SS 1034558 OBD16 M2,108SD & 114SD Allison transmission not shifting due to harness chafing

Applicable Vehicles:

M2, 108SD and 114SD OBD 2016 vehicles with Allison 1K, 2K, 3K and 4K transmission.

Picture 1

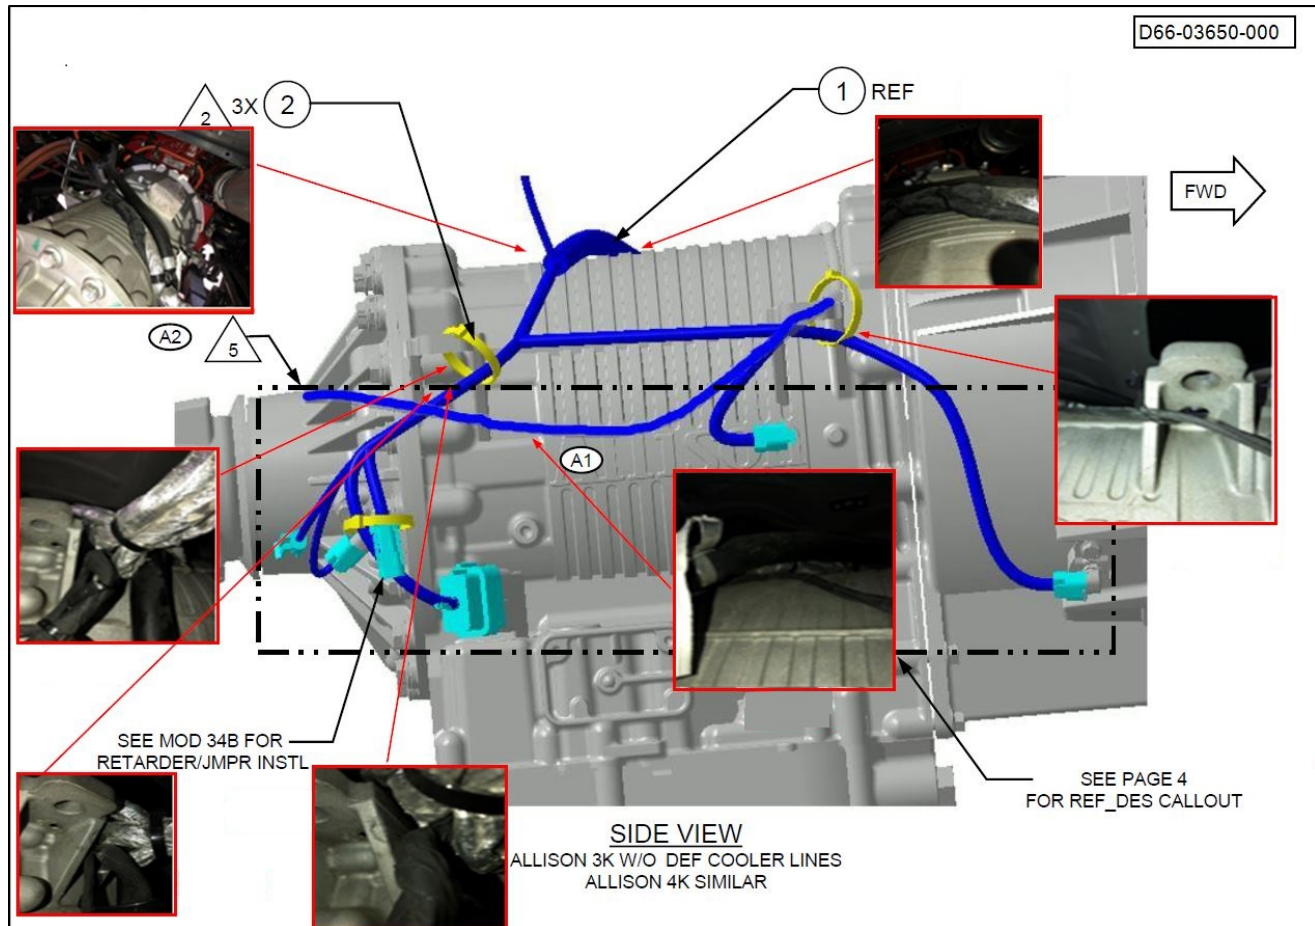
Chaffing can occur on several areas of the transmission wiring as noted in the first picture 1 below. The example picture is of an Allison 3K transmission, but similar chaffing can occur on the 1K, 2K and 4K transmissions. Over time the chaffing can lead to wires coming in contact with each mounting point and or wires coming in contact with each other.

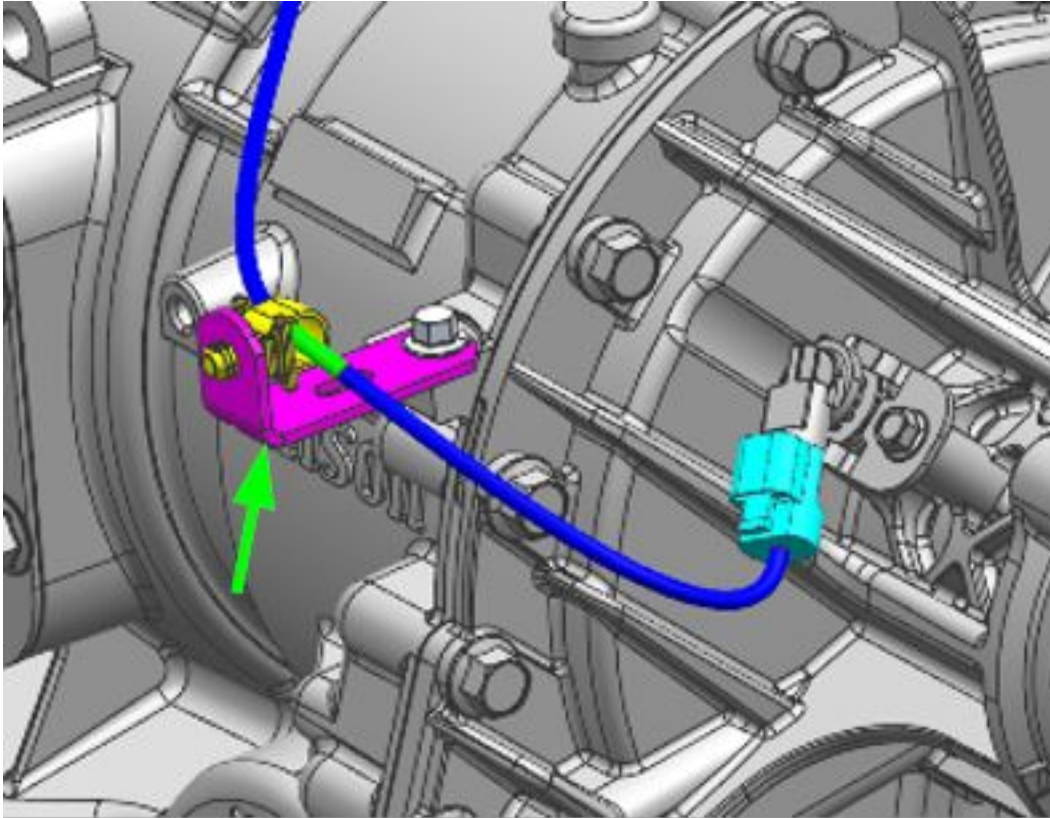
1. **A) RH Single Fuel Tank configurations:** Mount 23-09130-017, 23-13974-020 and 23-13482-004 to move harness away from transmission housing.

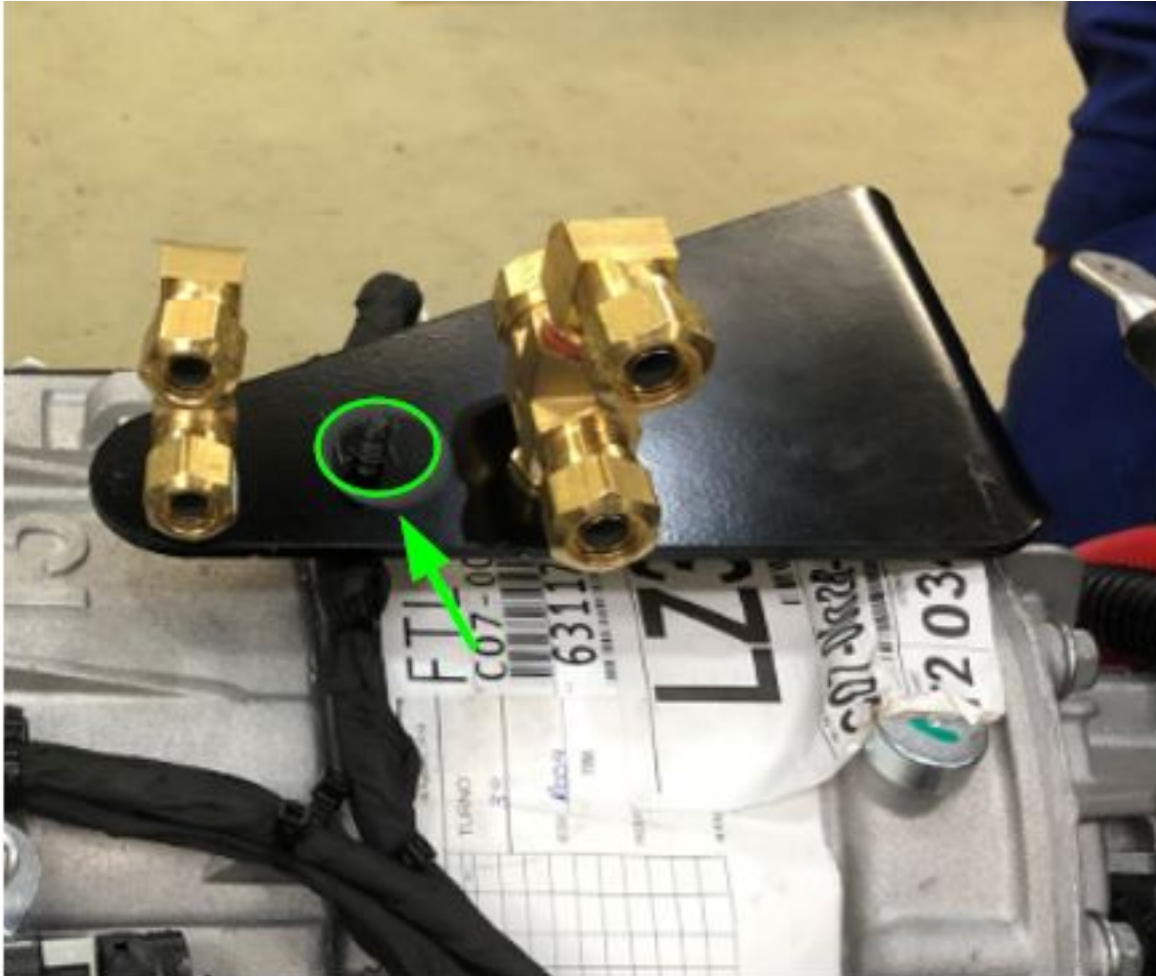
1. **B) LH Single Fuel Tank configurations:** Mount 23-09130-021, 23-13974-020 and 23-13482-003 to move harness away from transmission housing.

1. **C) Dual Fuel Tanks configurations:** Mount Fir tree 23-13482-003 below the fuel line bracket (The one used to mount the "Tee Valves").

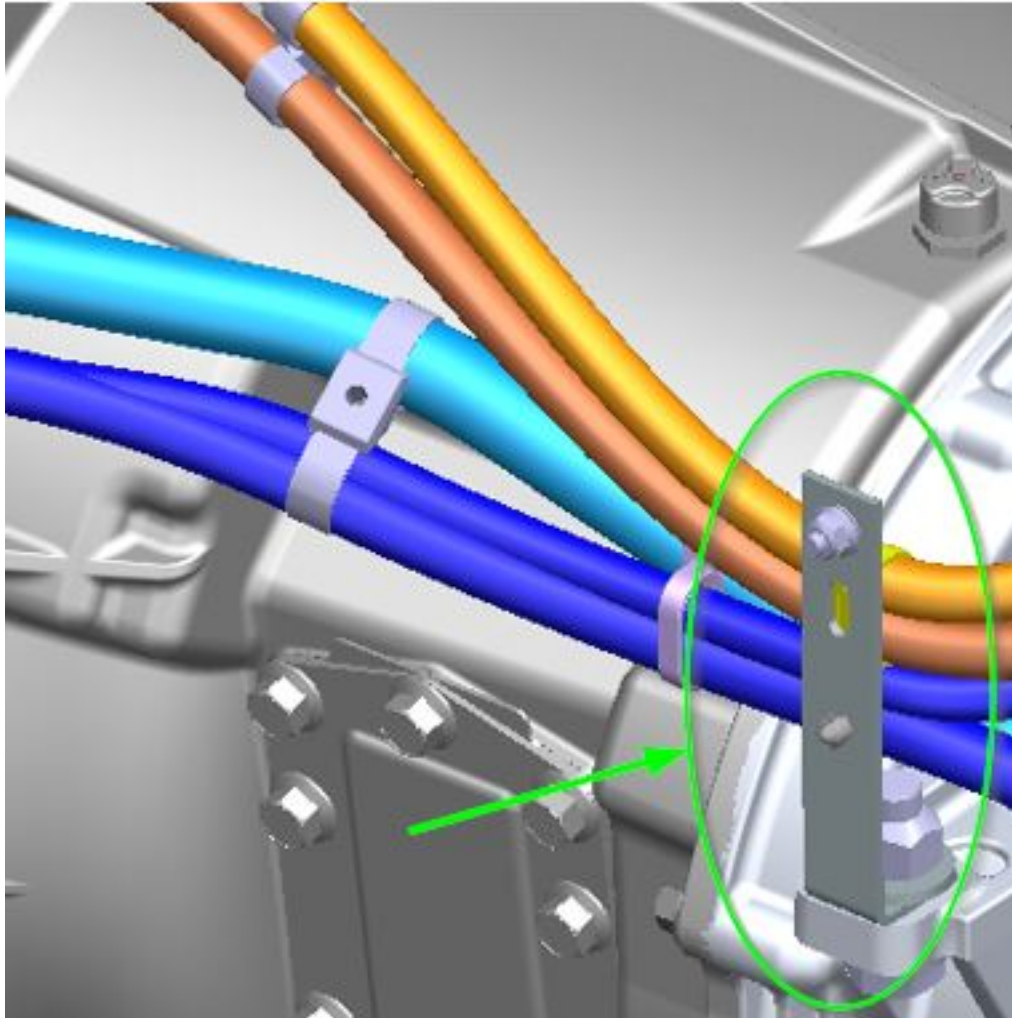
2. **Any fuel tanks configuration:** Use 06-09782-000 instead of 23-09130-033 when installing fuel lines. Use the bottom hole with 23-13482-003 to clip the transmission harness.

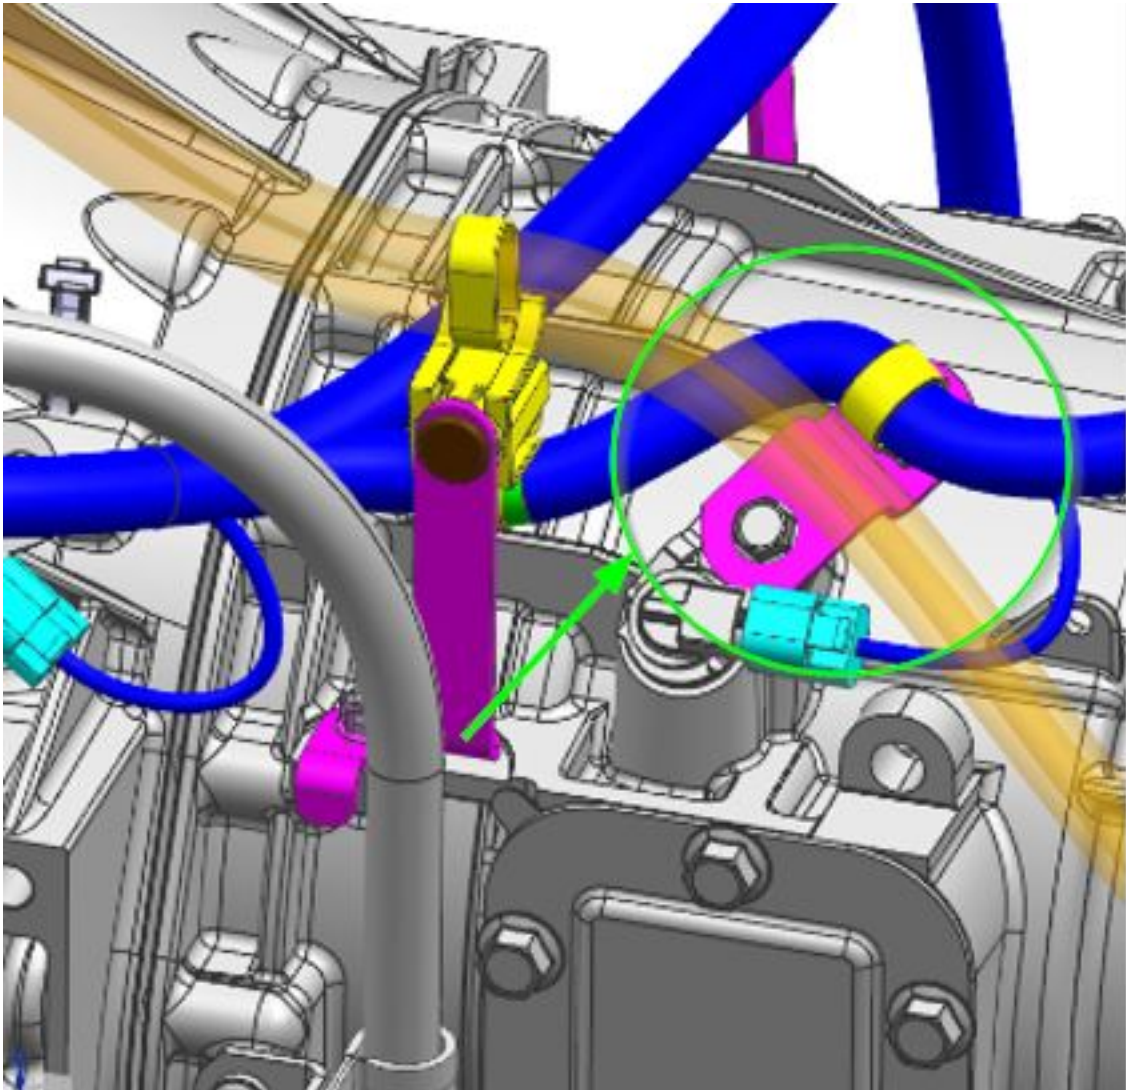
3. **Any fuel tanks configurations:** Use bracket 23-13863-000 together with Fir Tree 23-13482-004 near the Turbine Speed Sensor to move trans harness away from any rubbing component.

Harness Routing 2

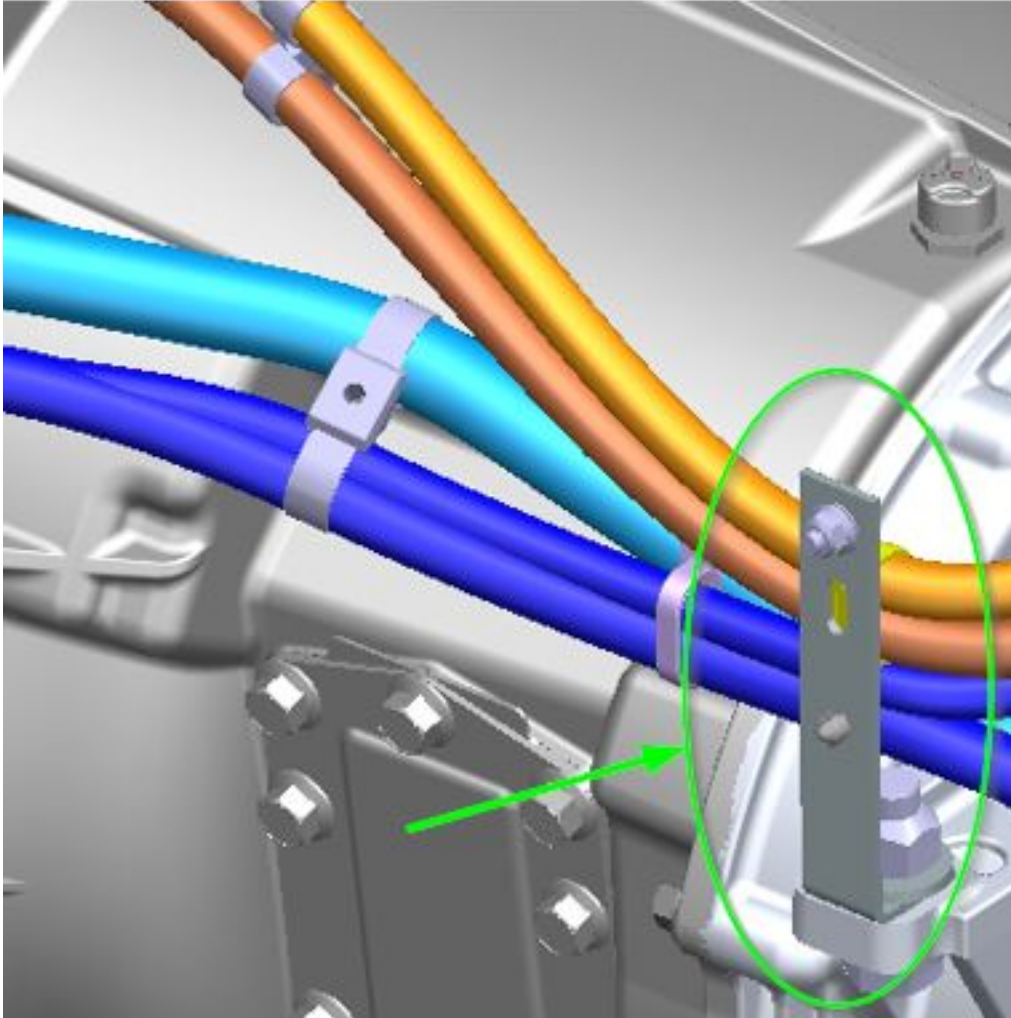
1. **A) RH single fuel tank:** Route harness together with fuel lines on LH and mount 06-09782-000 with 23-13482-003 on RH.

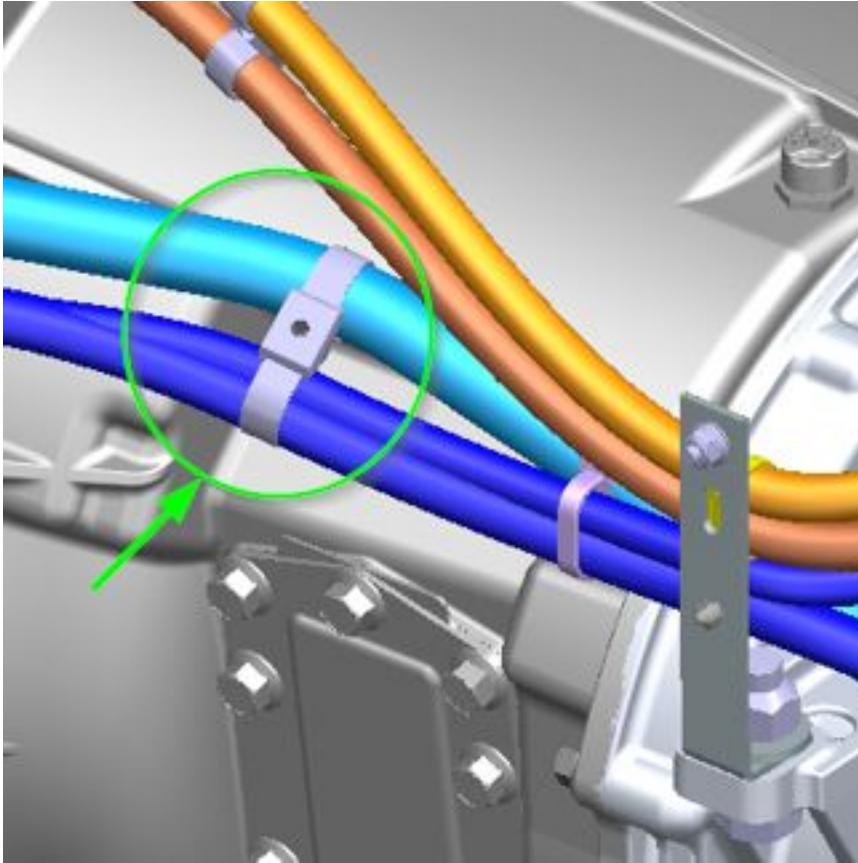
2. A.1 LH Single Fuel Tank: Route Trans Harness together with the fuel lines using butterfly tie straps (TYC DCT110HIR).

3. A.3) Dual Fuel Tank: Route harness together with the fuel lines and use the fuel line bracket to clip the harness using 23-13335-002 -TIE-MNT,FIR TREE 6.5-7MM,FT7.

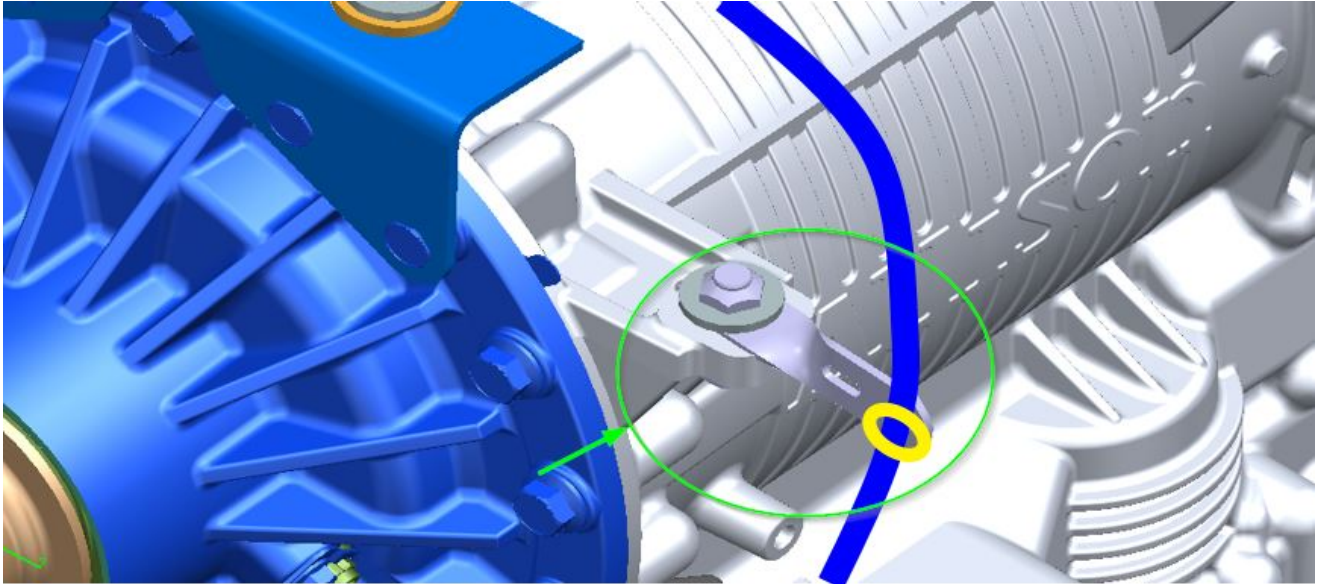
1. A For X12 and DD13 engines: Use the CLNT DEF lines to route the harness with Butterfly Tie Strap TYC DCT110HIR.

2 B On X12 and DD13 engines: Use bracket 23-09130-011, Nut 23-13833-108, washer 23-09114-000 and bolt 23-09440-150 on the Right side of the transmission to route the harness coming down from the CLNT DEF lines. Use 23-13482-003 -tie strap fir tree to clip the transmission harness to the bracket.

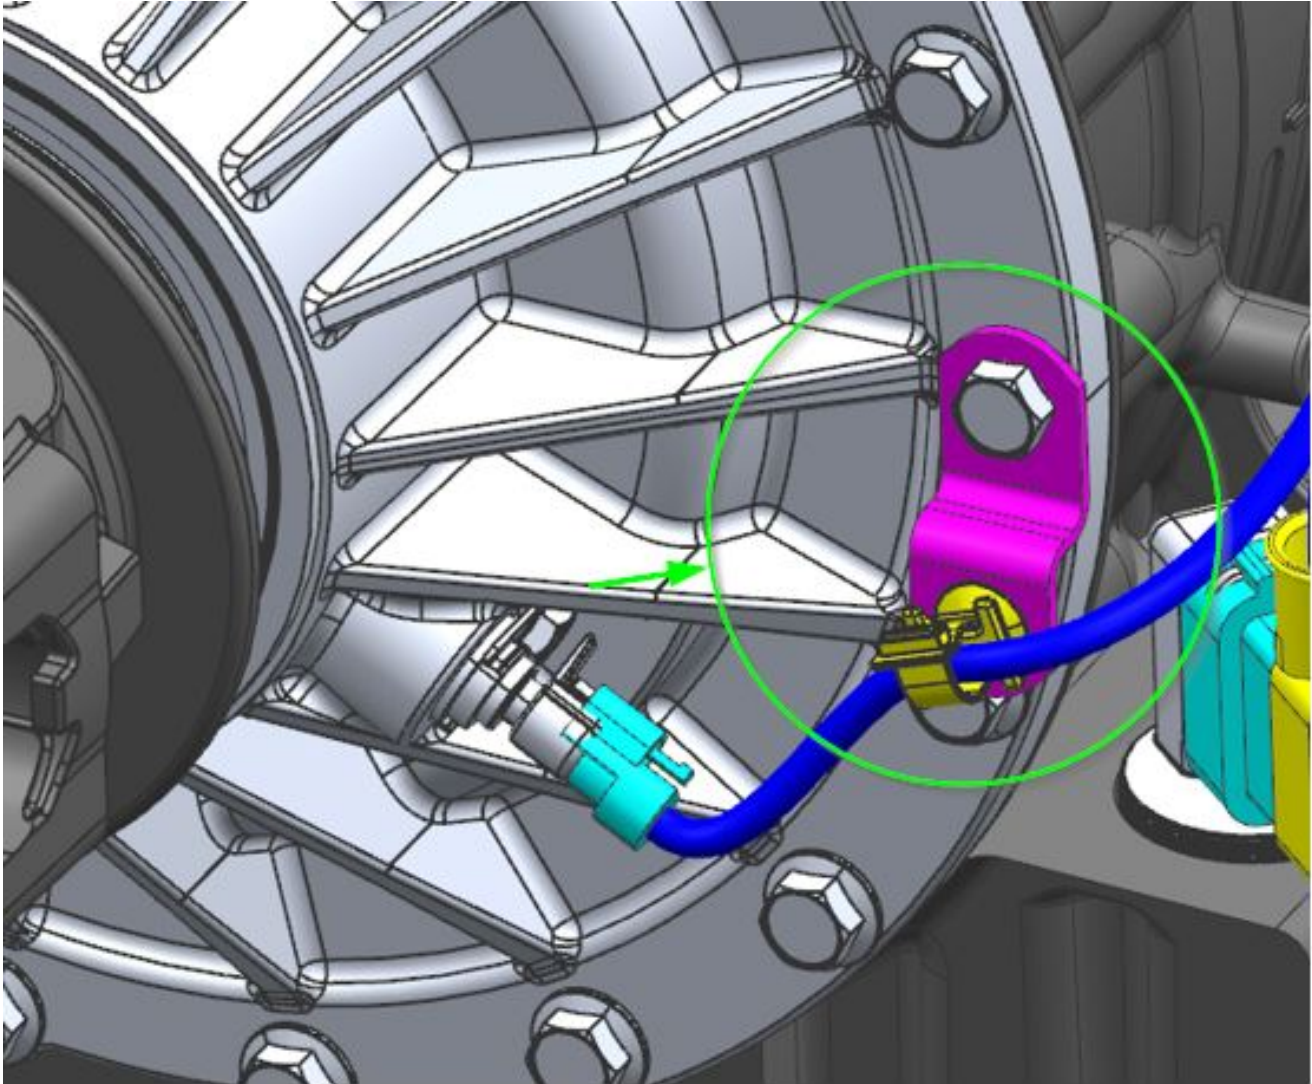
2 C For All engines: Use bracket 23-13863-000 on the Rear Front cover of the Transmission housing to move the harness away from screws and sharp edges. Use 23-13482-003 -tie strap fir tree to clip the transmission harness to the bracket.

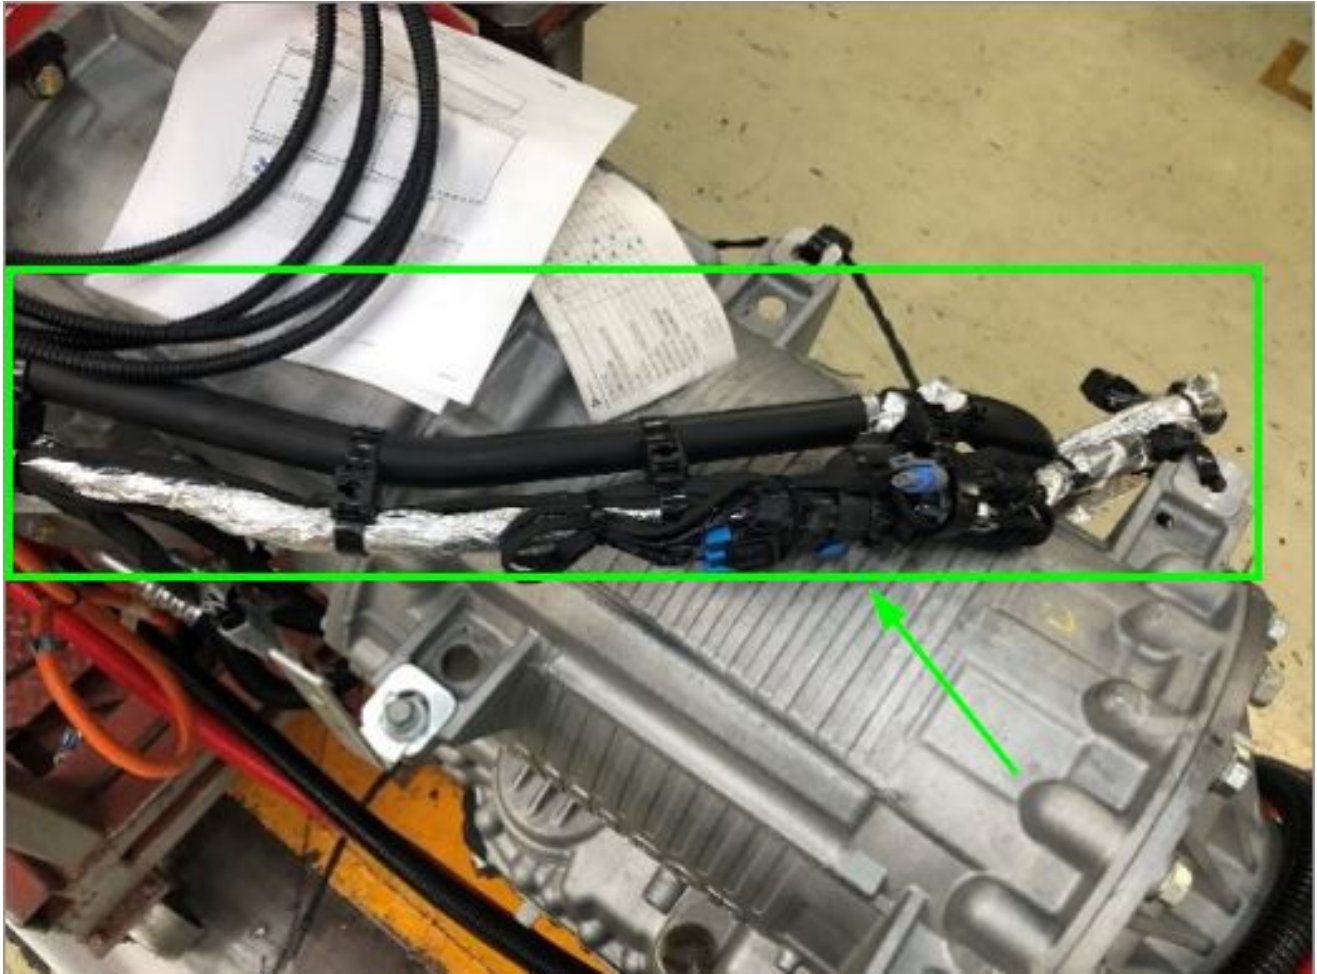
3 A If dipstick makes transition from the left to the right side, use it to route the harness with Butterfly Tie Strap TYC DCT110HIR:

▾ Make harness transition from the engine to the routing the harness together with the dipstick.
